DART AEROSPACE LTD	Work Order:	97457
Description: Gusset	Part Number:	D3016-15
Inspection Dwg: D3016	Rev: A	Page 1 of 1

DESIGN <i>CP</i>	DRAWN BY <i>CP</i>	DART AEROSPACE LTD HAWKESBURY, ONTARIO, CANADA	
CHECKED <i>#</i>	APPROVED <i>#</i>	DRAWING NO. D3016	REV. A SHEET 1 OF 3
DATE 01.05.18		TITLE SEAT FRAME ASSEMBLY	SCALE NTS
A	01.05.18	NEW ISSUE

DRAWING NO. D3016	TITLE SEAT FRAME ASSEMBLY	REV. A	DART AEROSPACE LTD ENGINEERING ORDER		D.E.O. NO. D3016-A-1	SHEET NO. SHEET 1 OF 1	SCALE NTS
DRAWN <i>1</i>	CHECKED <i>UP</i>		MFG. APPR. <i>RE</i>	APPROVED <i>MAP</i>	DE APPR. <i>MAP</i>		
DATE 10.01.29	DATE 10.01.29		DATE 10.01.29	DATE 10.01.29	DATE 10.01.29	DATE 10.01.29

TO REVISE D3016-11 SADDLE'S HOLE SIZES

D3016-11 SADDLE

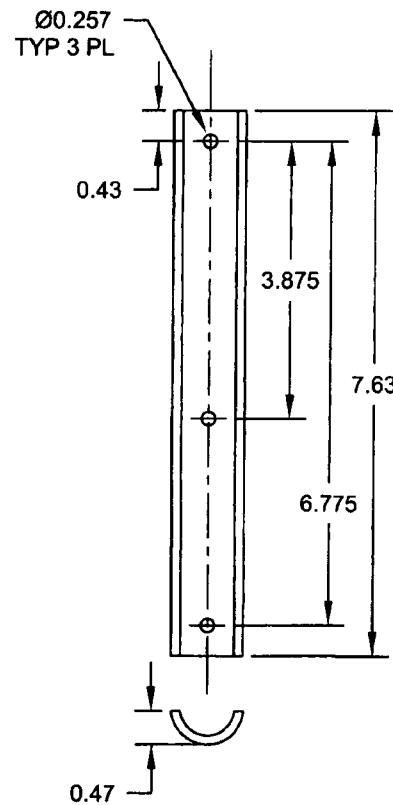
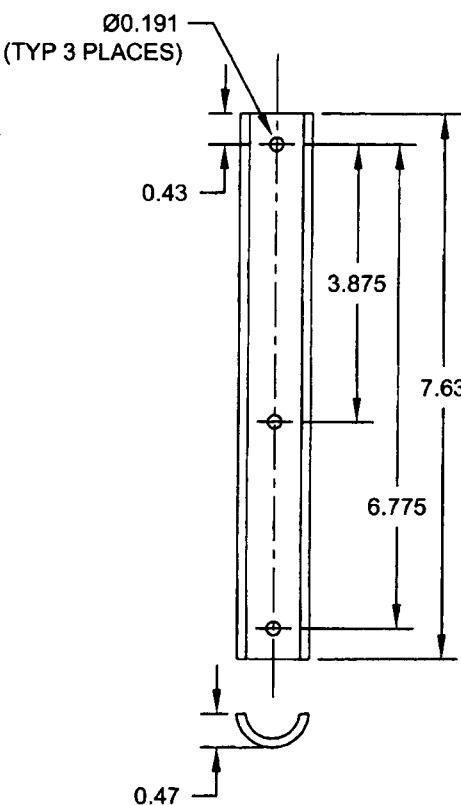
DETAIL D3016-11 SADDLE (SHEET 3): Ø0.257 TYP 3 PL WAS Ø0.191 (TYP 3 PLACES) AS SHOWN:
